CHABOT-LAS POSITAS COMMUNITY COLLEGE DISTRICT PURCHASING DEPARTMENT

Addendum No. 2

REQUEST FOR PROPOSAL BID: B23/24-05 Pool Resurfacing Project at Las Positas College

DP-9

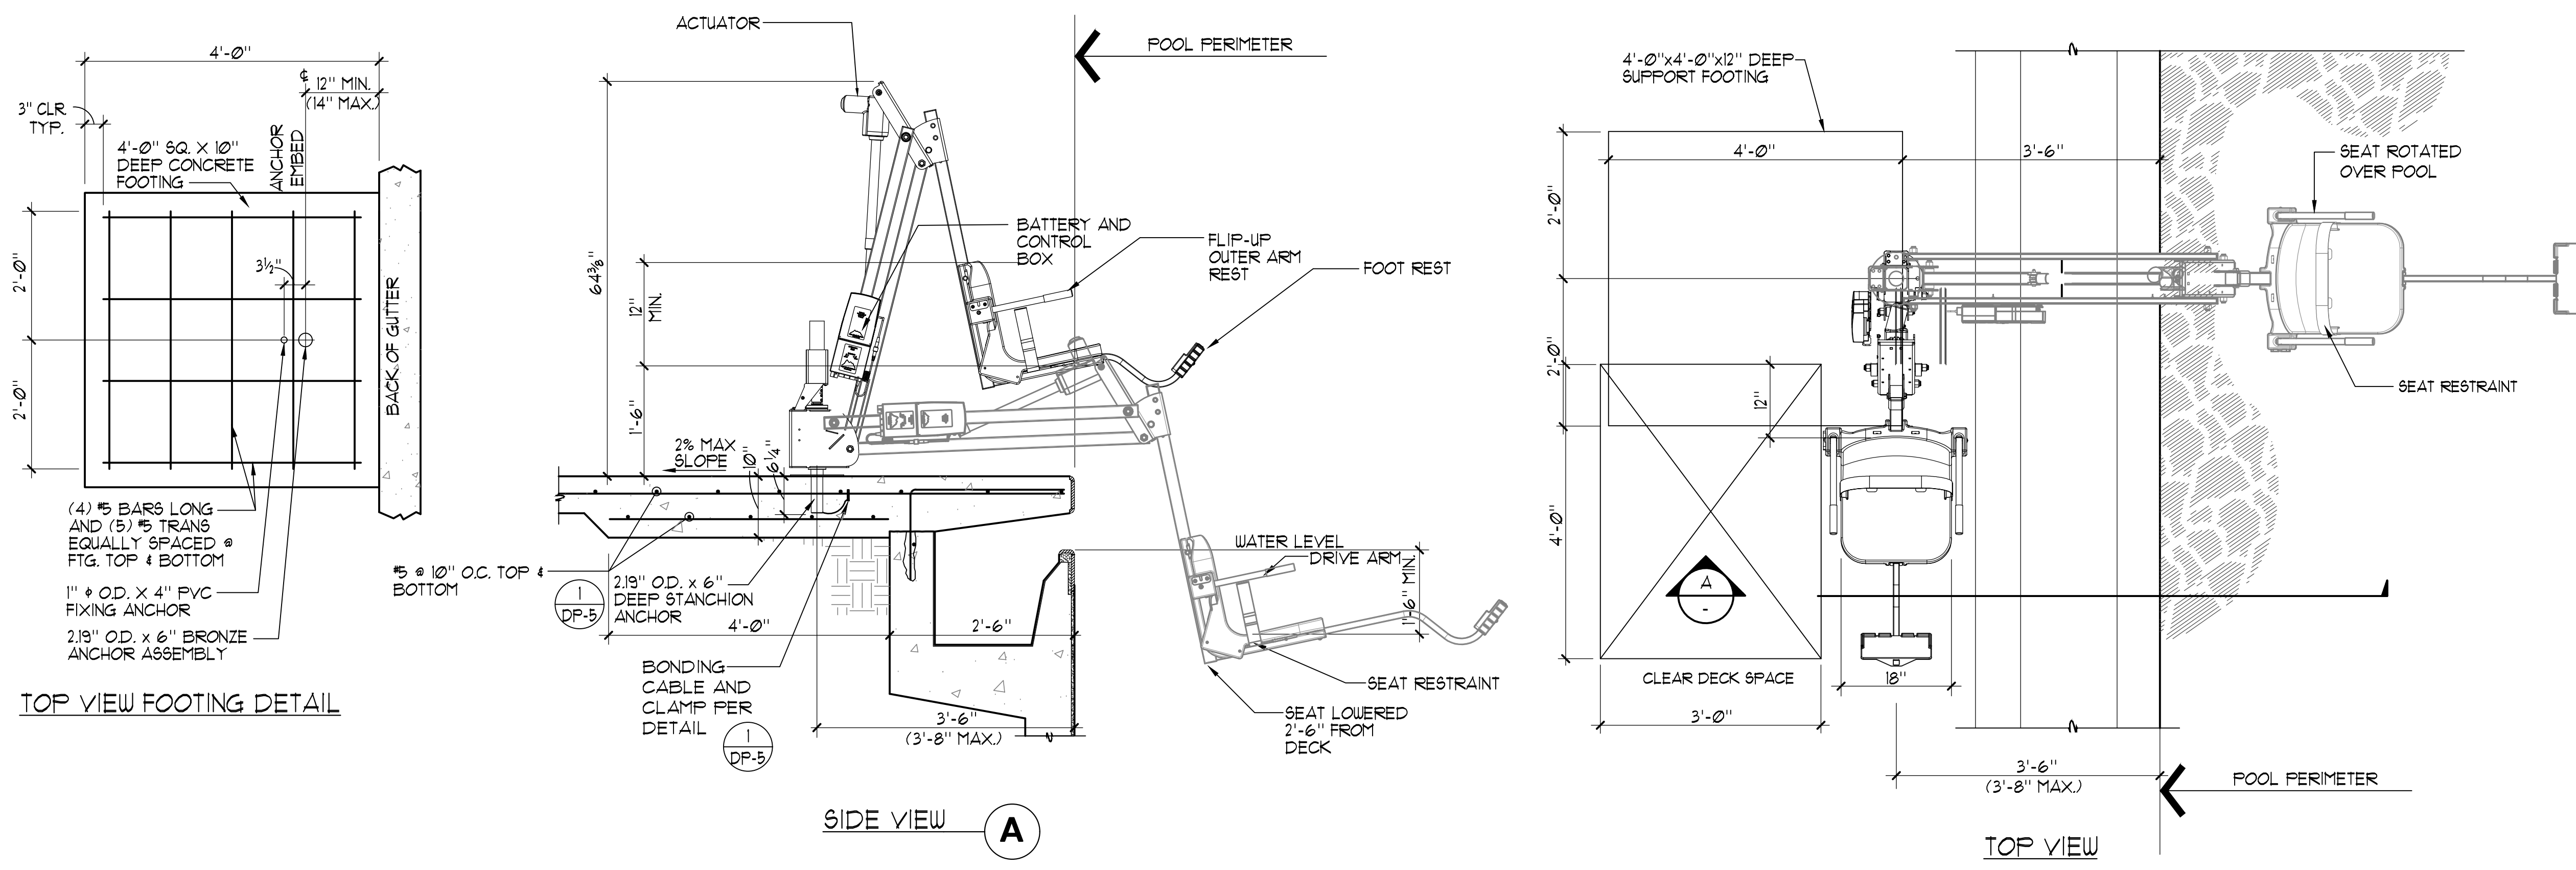
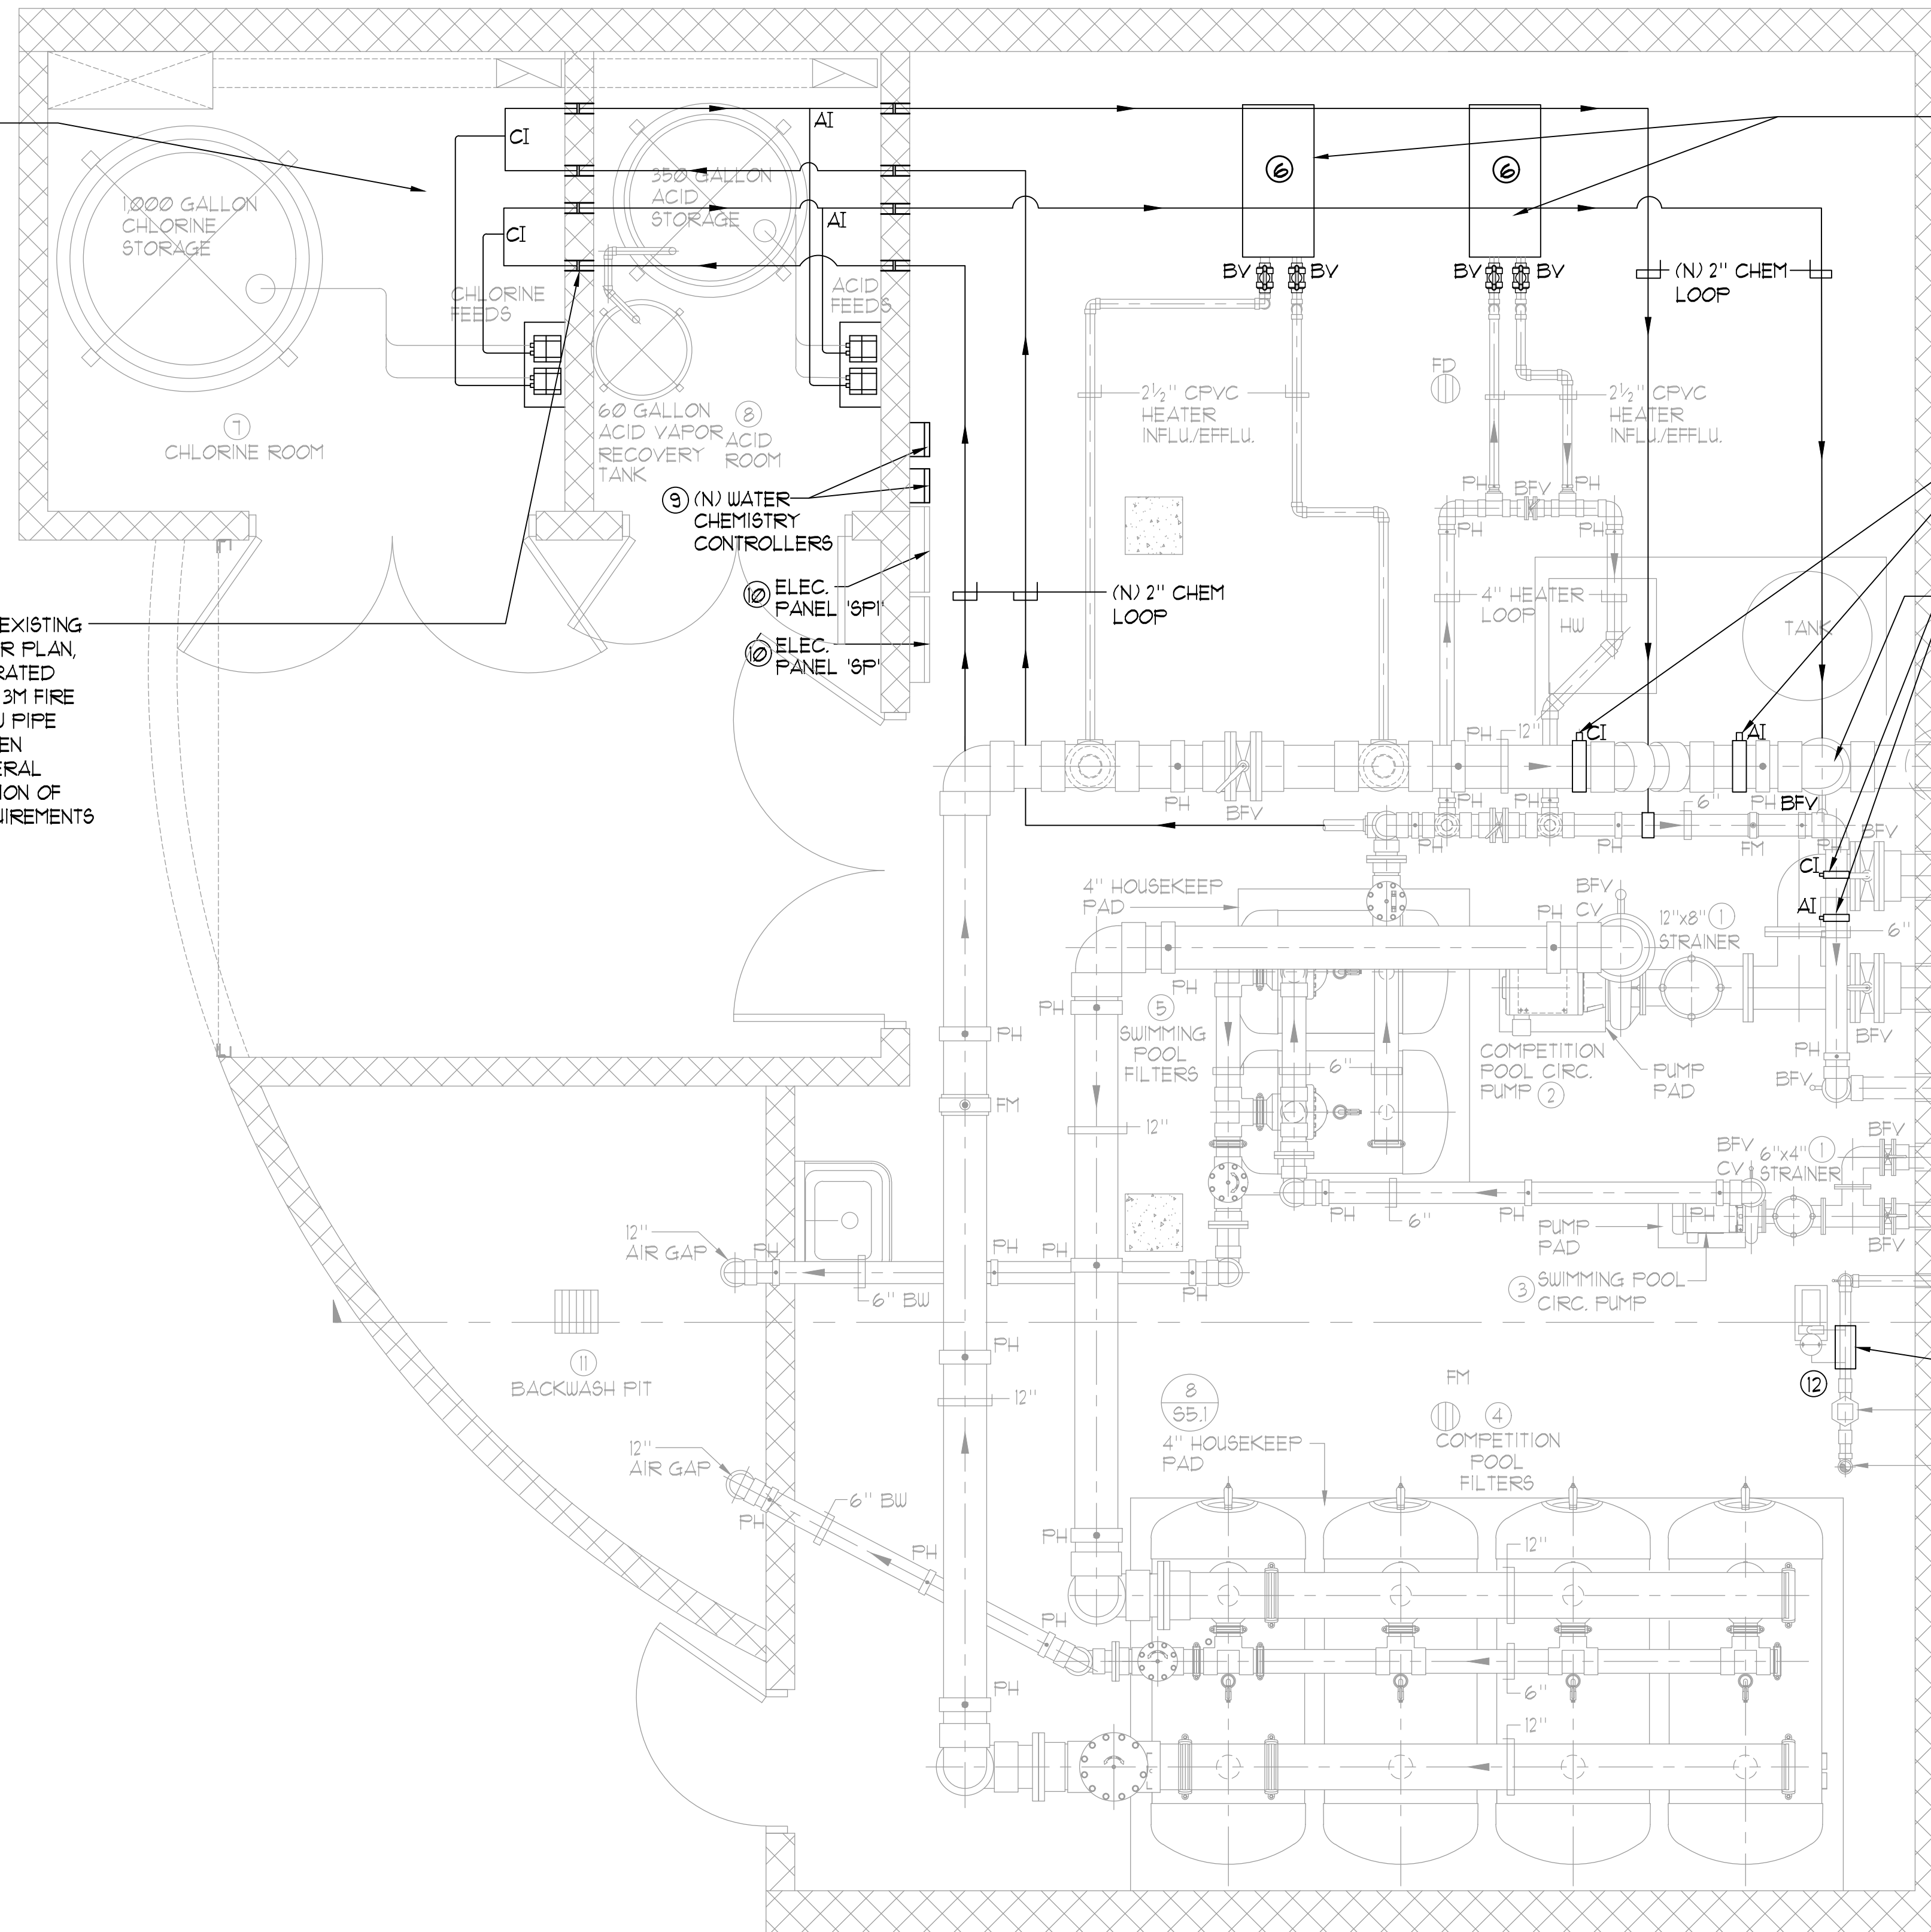
7. **Sheet DP-7 Details:** Reference detail #4 for Deck Joint Details and RFI response #14.
8. **Sheet DP-9 Details:** Clarifications provided on note #1

COMPETITION POOL/SWIMMING POOL UNDERWATER LIGHT/TIMING SYSTEM PLAN

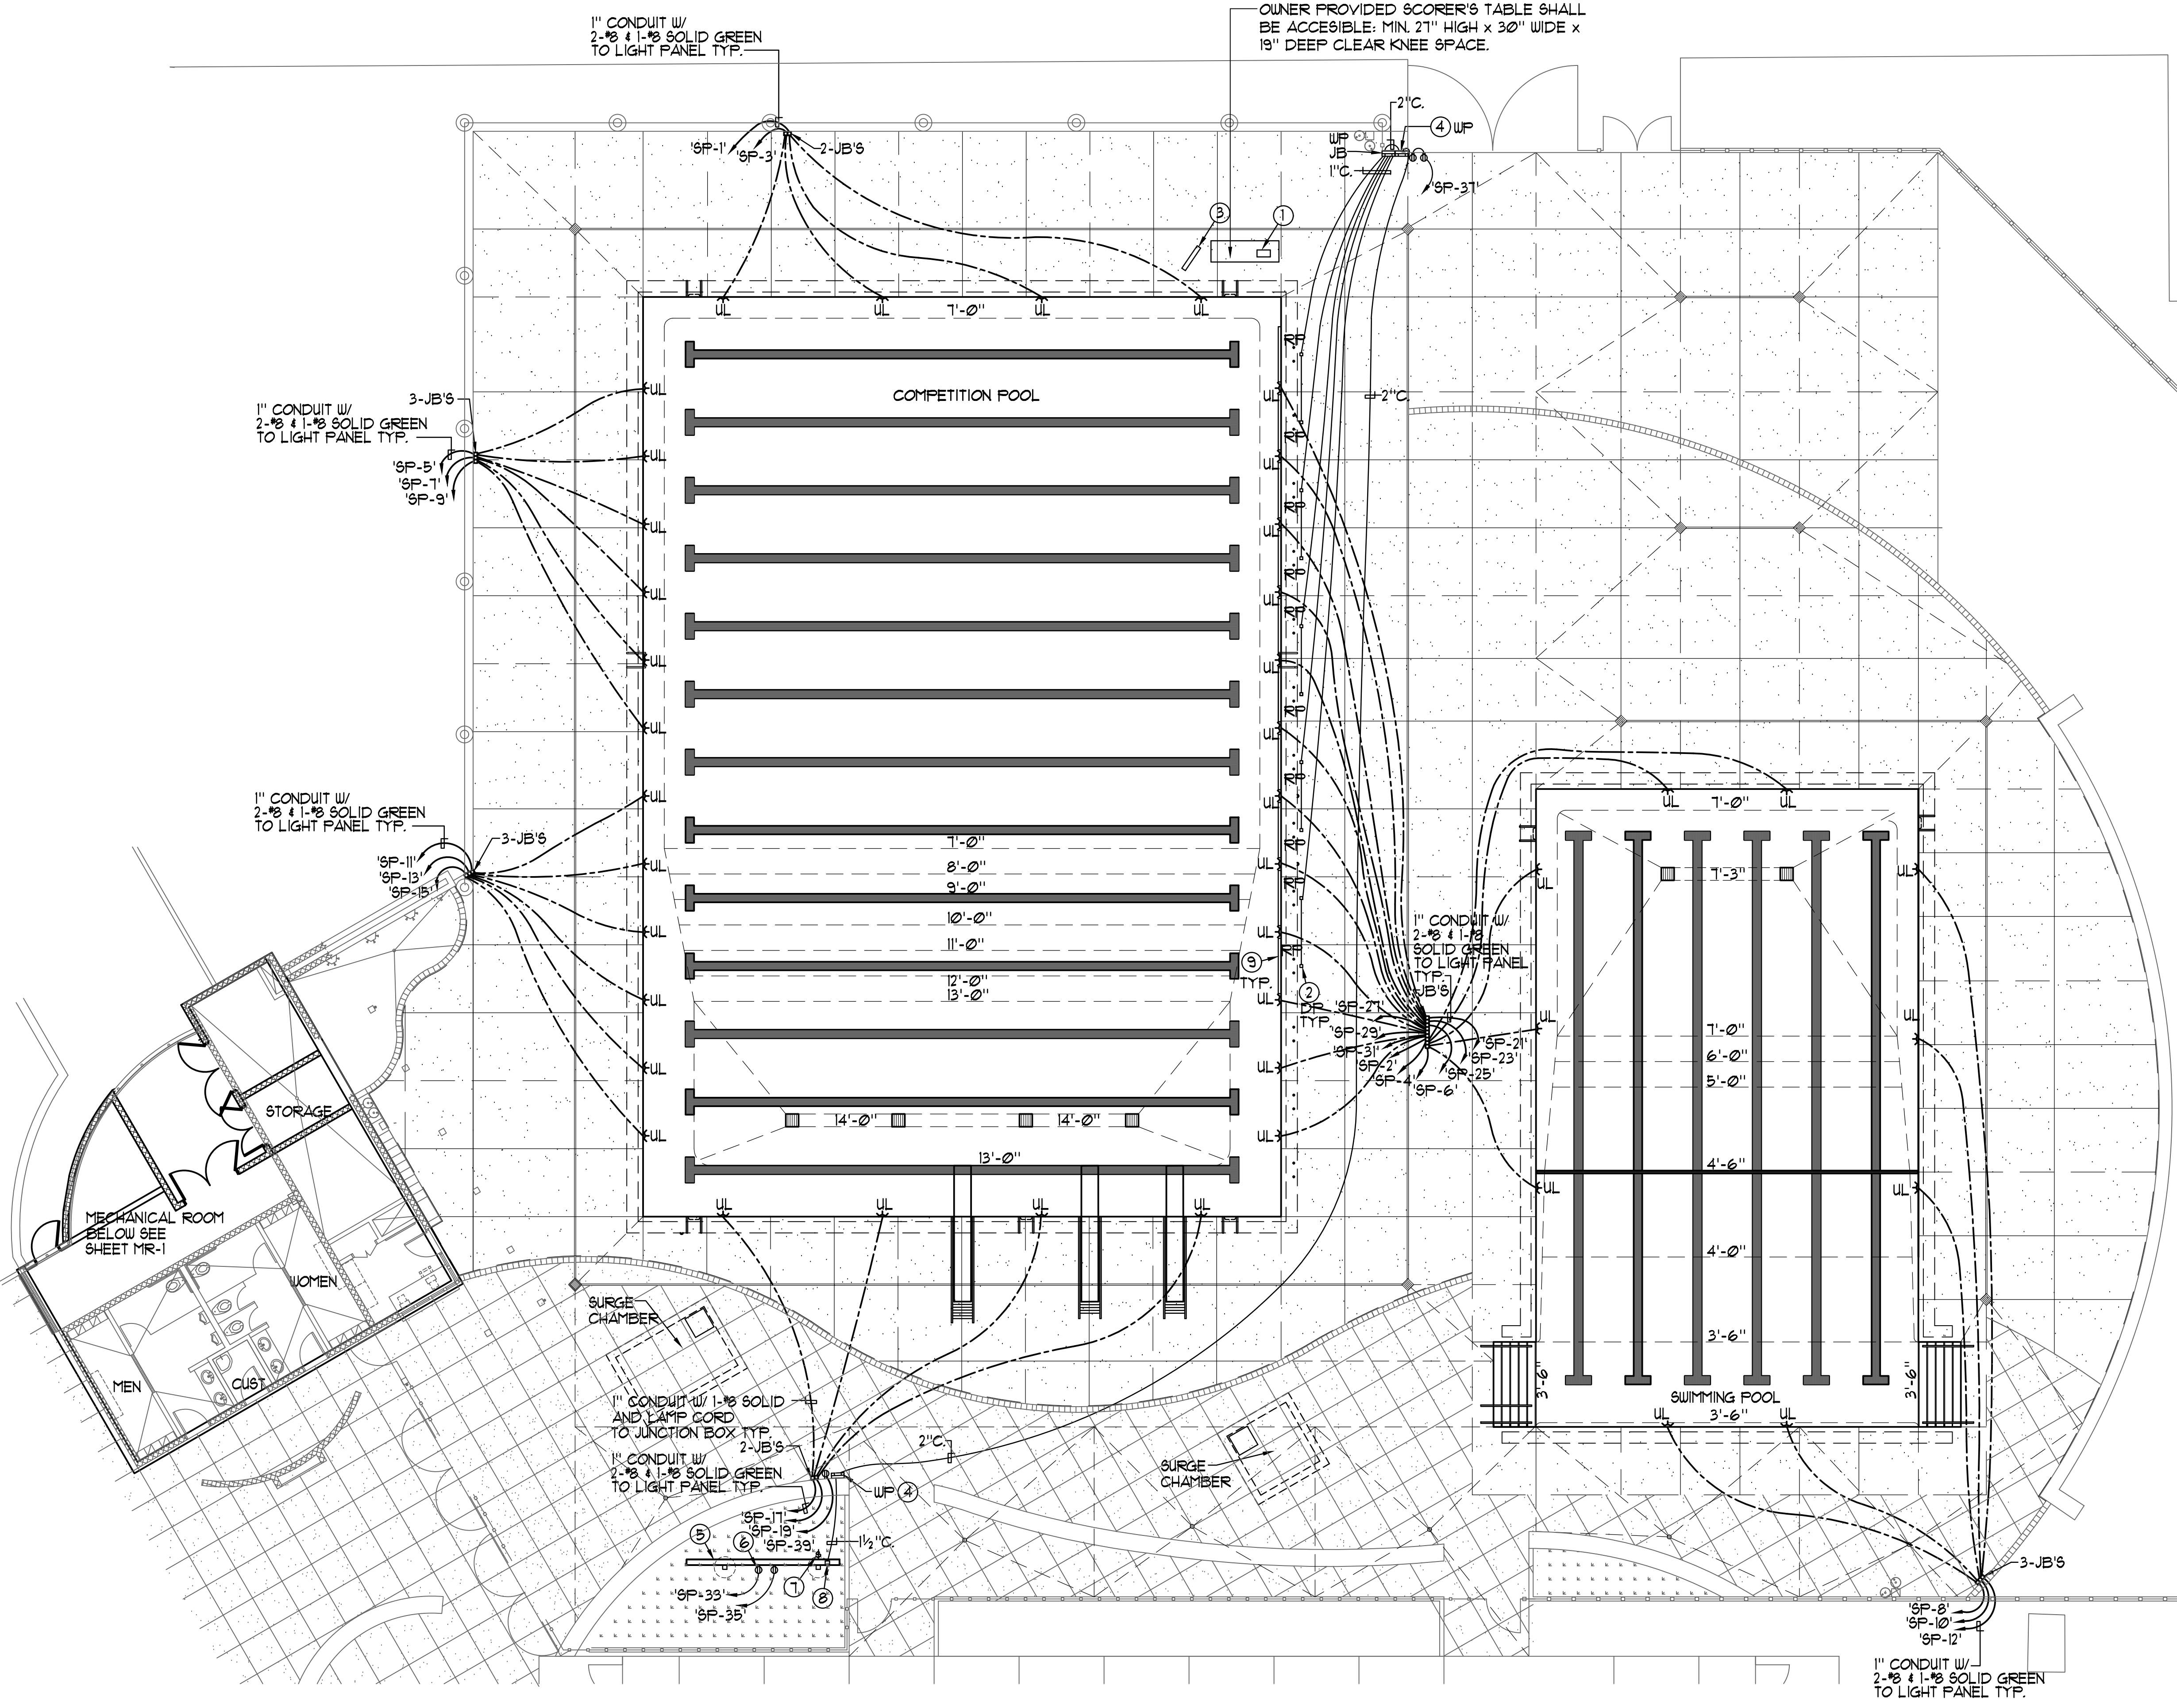
Question No. 7: There appears to be an existing in-deck Colorado time system that is not identified on the plans. In order to provide an accurate cost for the Add Alternate option, please provide qty and locations of timing system deck boxes at starting platforms and provide corresponding replacement details.

Response: ADG Response: Please see the attached original timing system plan.
